SKYLINE-PARADISE HILLS COMMUNITY PLANNING GROUP

PUBLIC NOTICE and AGENDA

7. 7:25 **Action Items**
- A. Review and vote on removing and replacing antennas on existing cell site (PRJ-1159627)
 - a. *Remove six antennas, six remote radio units (RRUs), and three horizontal mast pipes, and install six antennas, three RRUs, eight-foot horizontal mast pipes, and other associated ancillary equipment at 6780 Aviation Drive*

OVERALL SITE PLAN

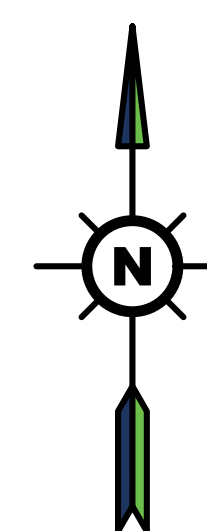
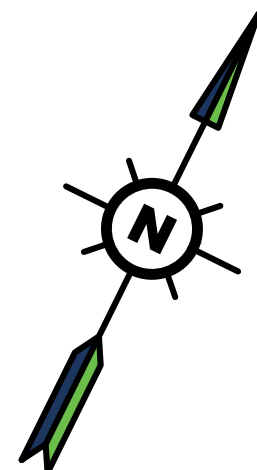
vi. The location of existing buildings and structures are shown. Please include use of all existing buildings e.g. residential, school, church and structures on Site Plan.

Consistency: Clearly identify the property line and ensure Landscape Plan is consistent with Site Plan.

Please show and identify all existing trees. Showing all existing trees on the site plan will help demonstrate additional landscaping would not be beneficial in screening the WCF.

BRANCHING DETAIL

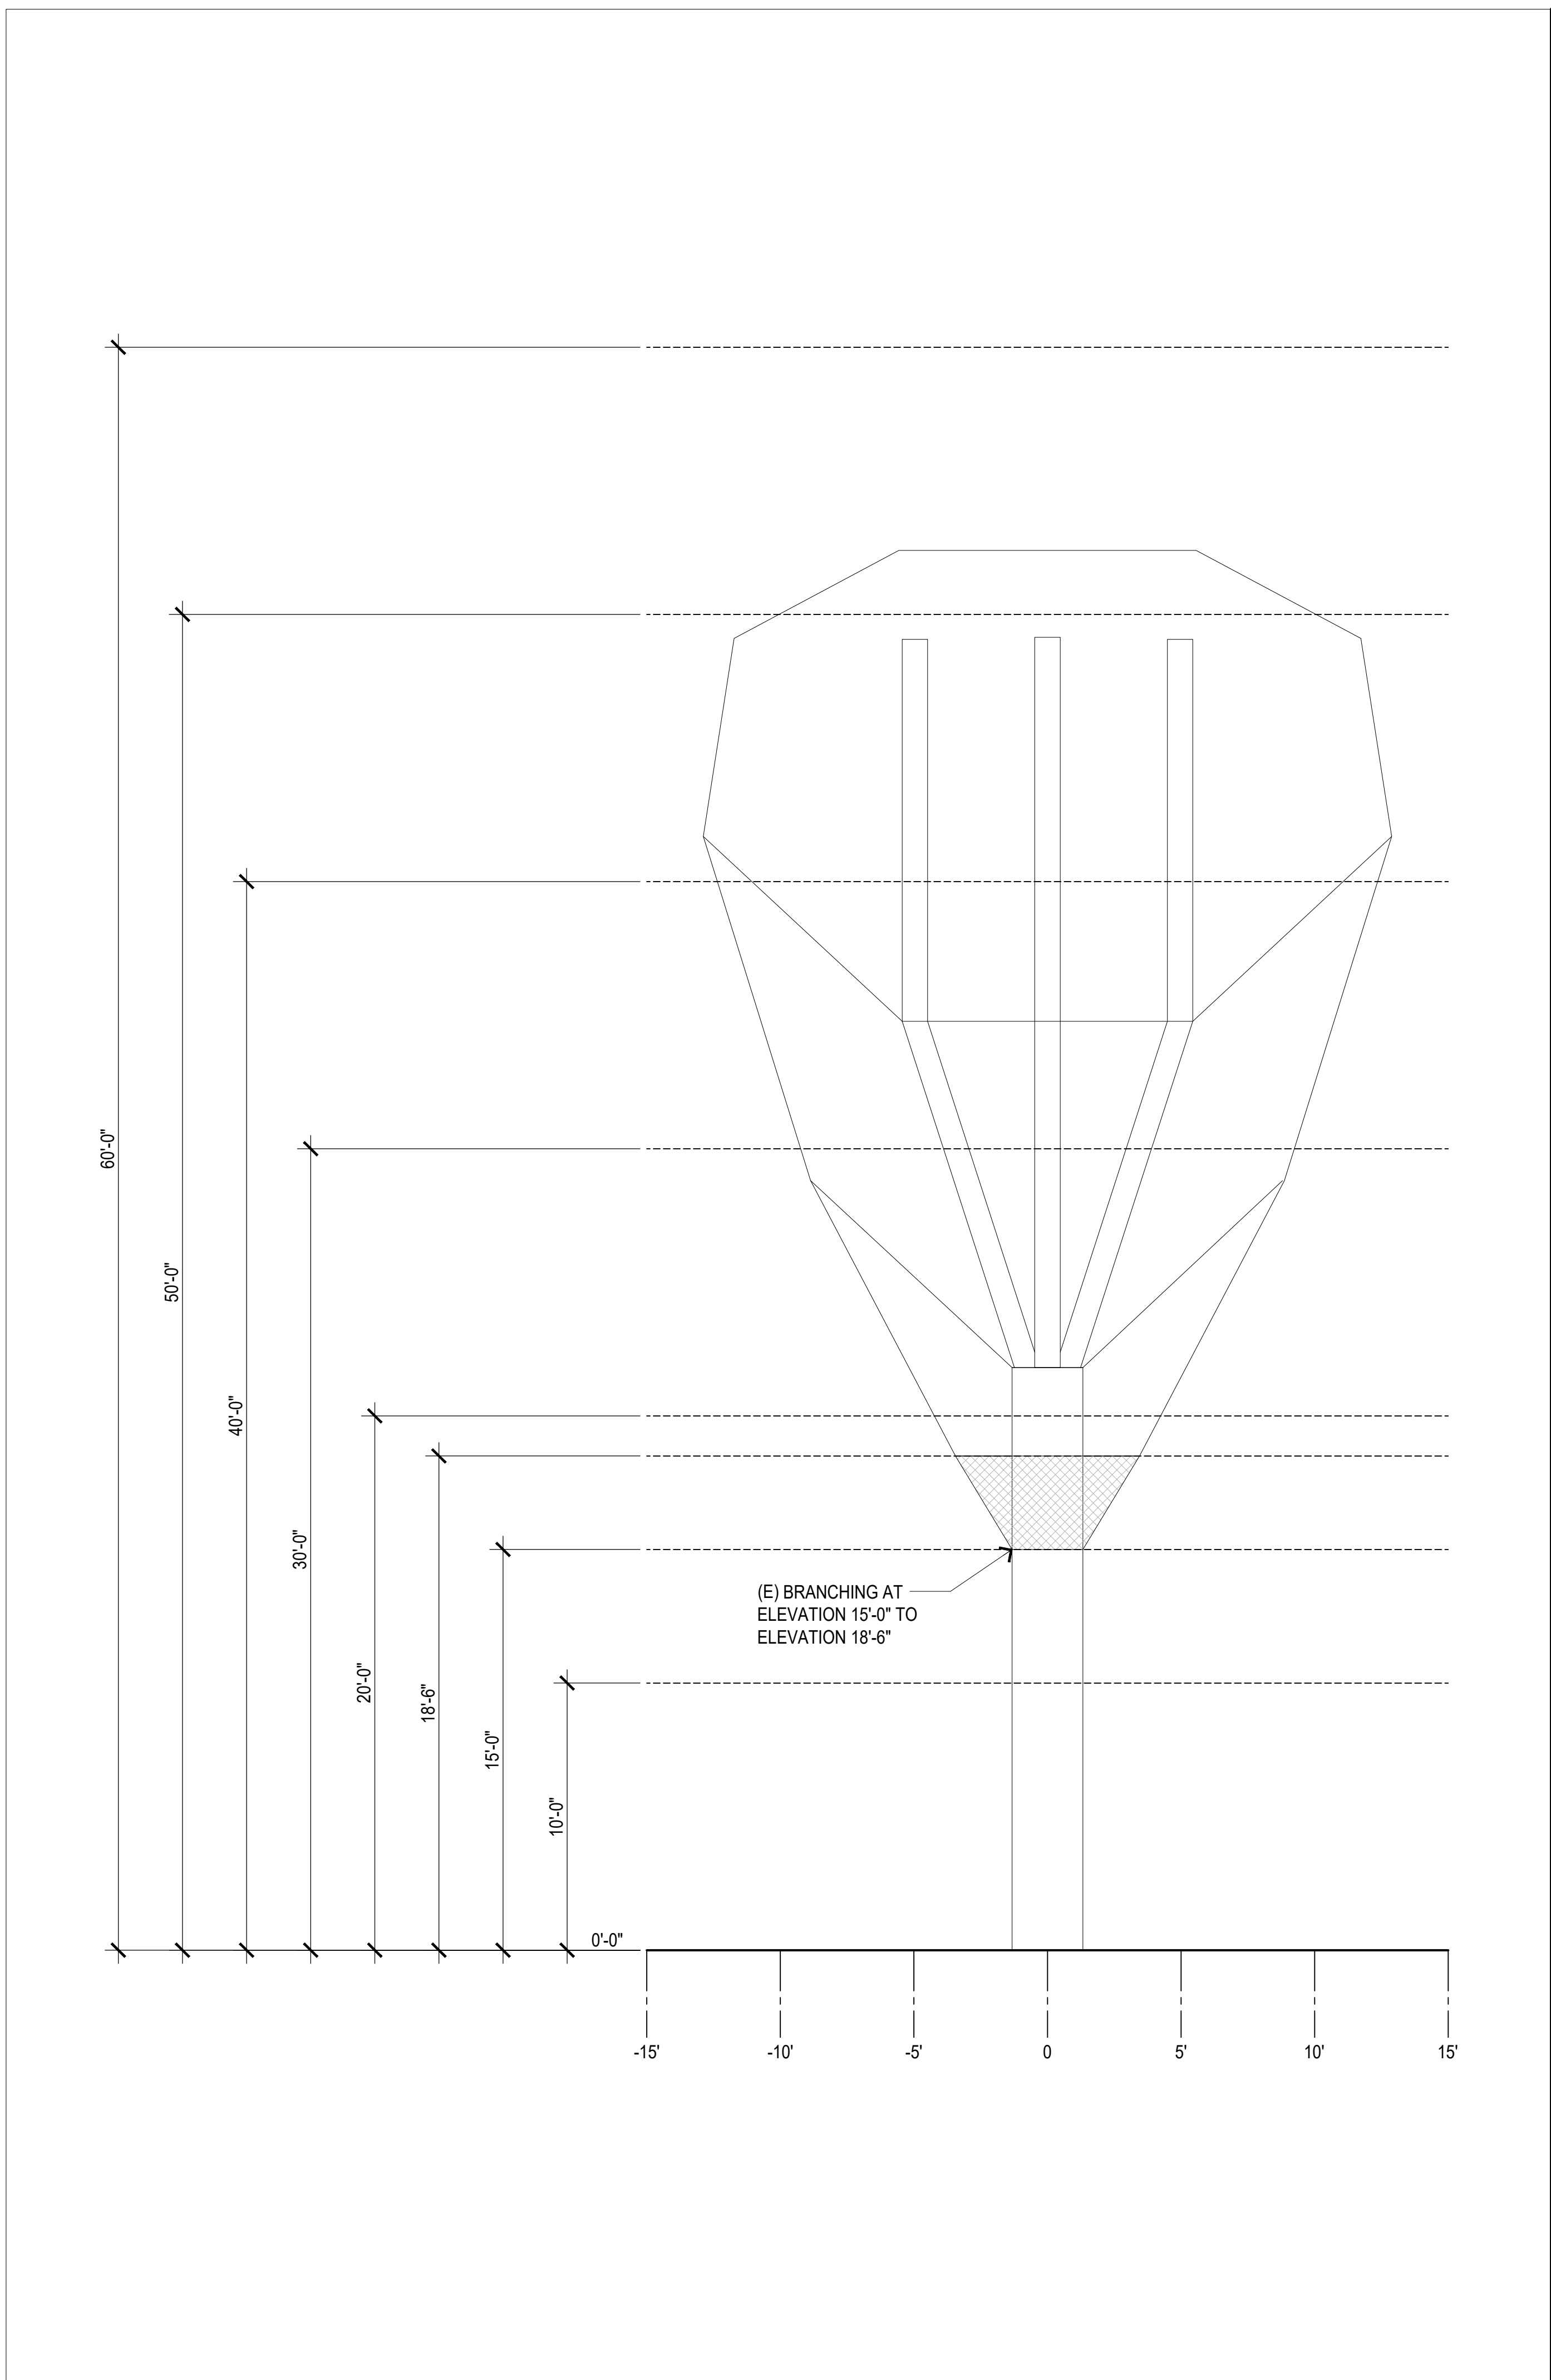
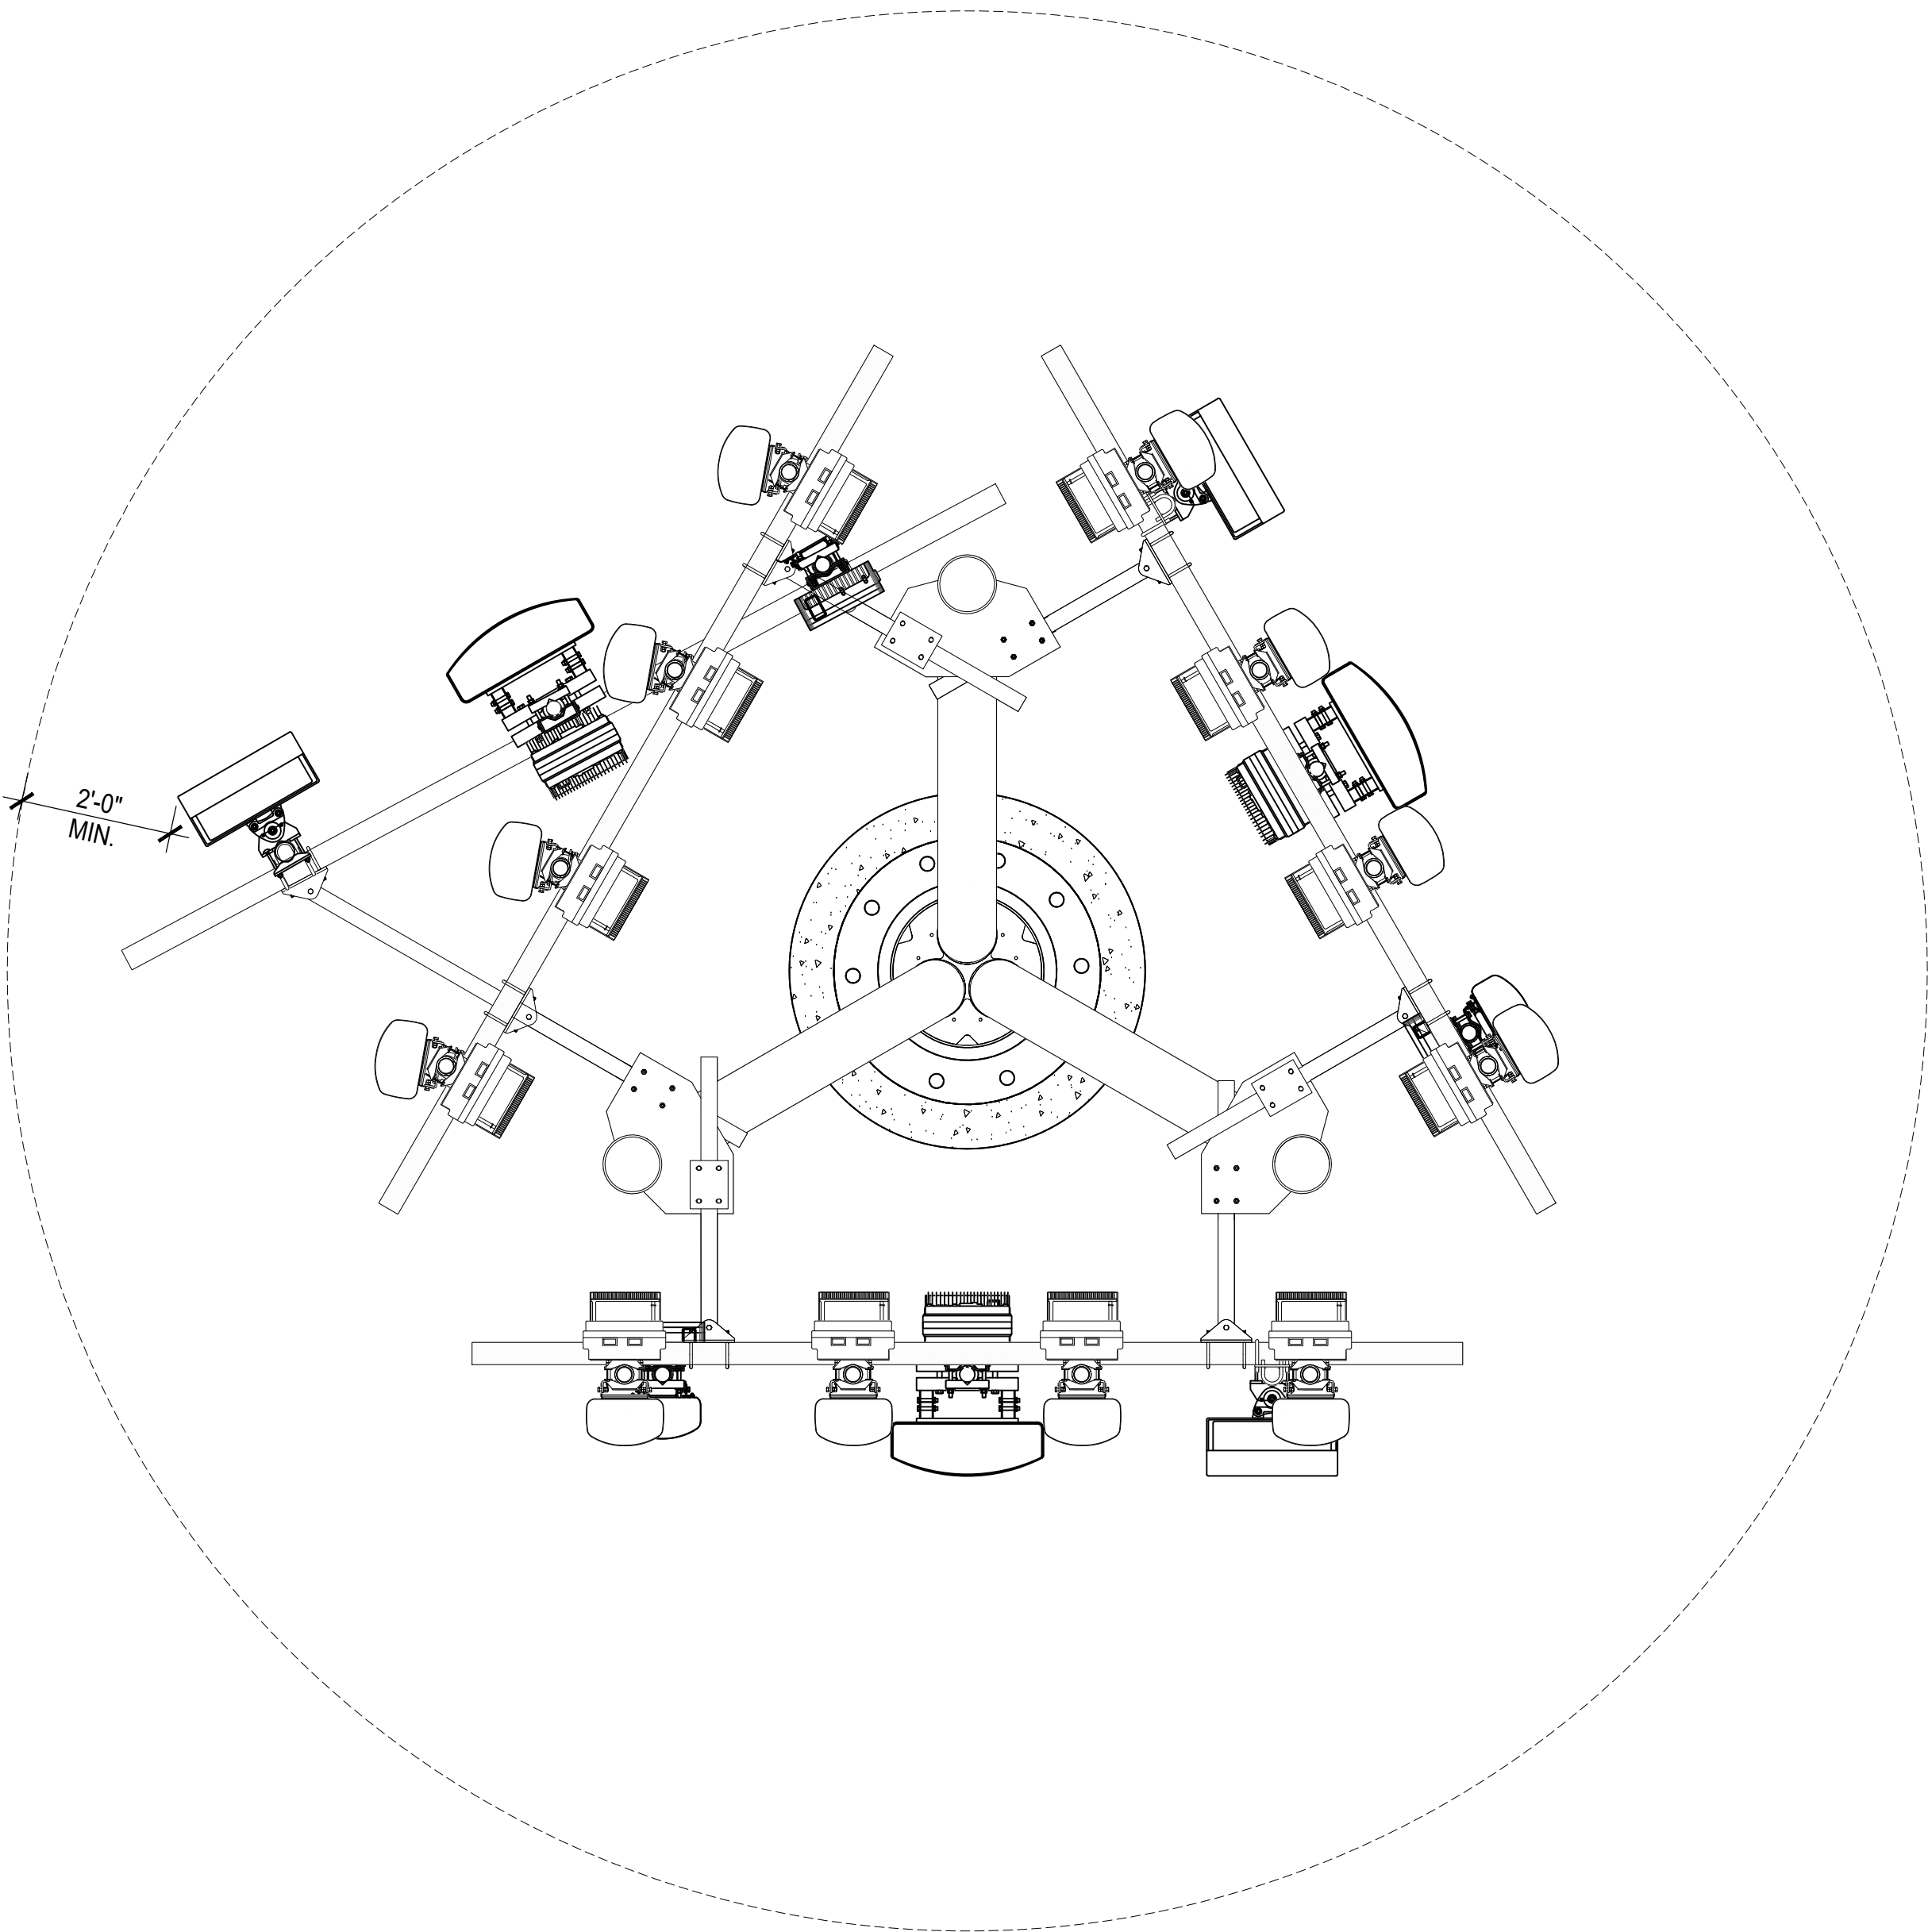
Add Standard Starting Branch Height

Show the starting branch height. 10 ft. is the standard starting branch height for similar faux trees.

Any changes to branches will require a building permit and should appear on the scope of work of any plans submitted. Faux vegetation should not be rebranched without a permit, even if there is no other work.
